# Service Bulletin No. 389

<b>MODEL</b> D / E / J Series Coaches	<b>TYPE</b> Field Change Program	<b>SECTION/GROUP</b> 7--Electrical	<b>DATE</b> Oct. 12, 2012
<b>SUBJECT</b> RETENTION NUT ON LEECE NEVILLE ALTERNATOR			
<b>CONDITIONS</b>

**Figure 5. Reference photo.**

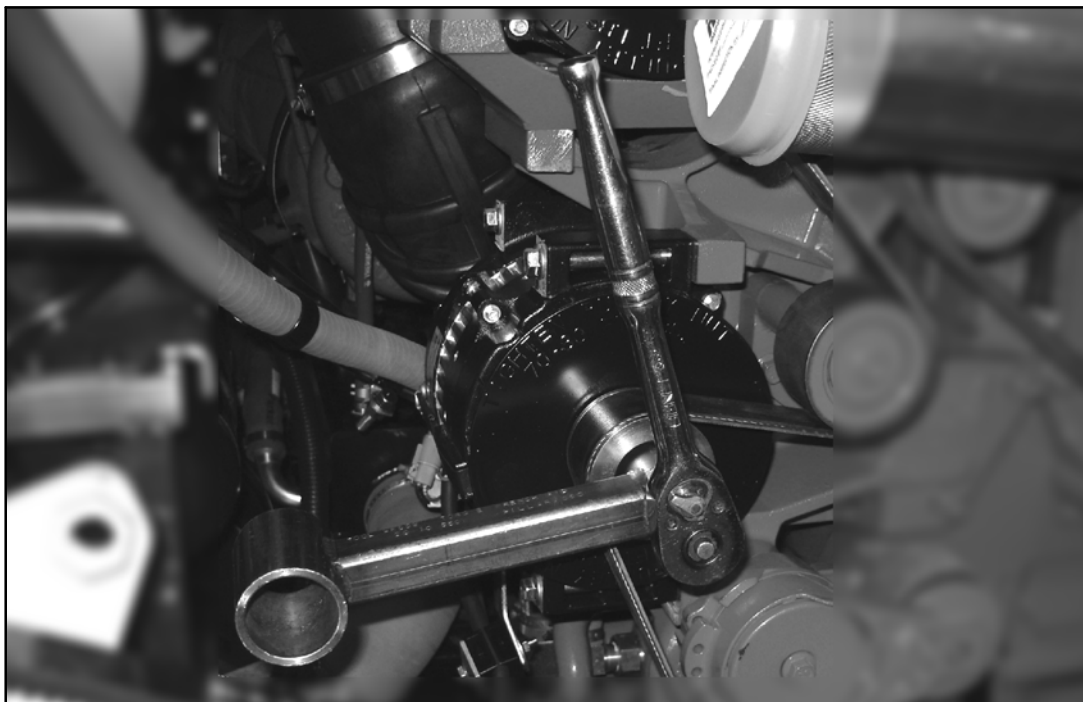
9. Using the two ( 2 ) reference tools shown in Figures 5 and 6 simultaneously, remove and discard the existing pulley nut from the alternator.

10. Install and tighten the new nut, p/n 07-03-1285, on the alternator. Torque nut to 70– 80 ft.-lbs.
11. Repeat Steps 9. and 10. to the second alternator.
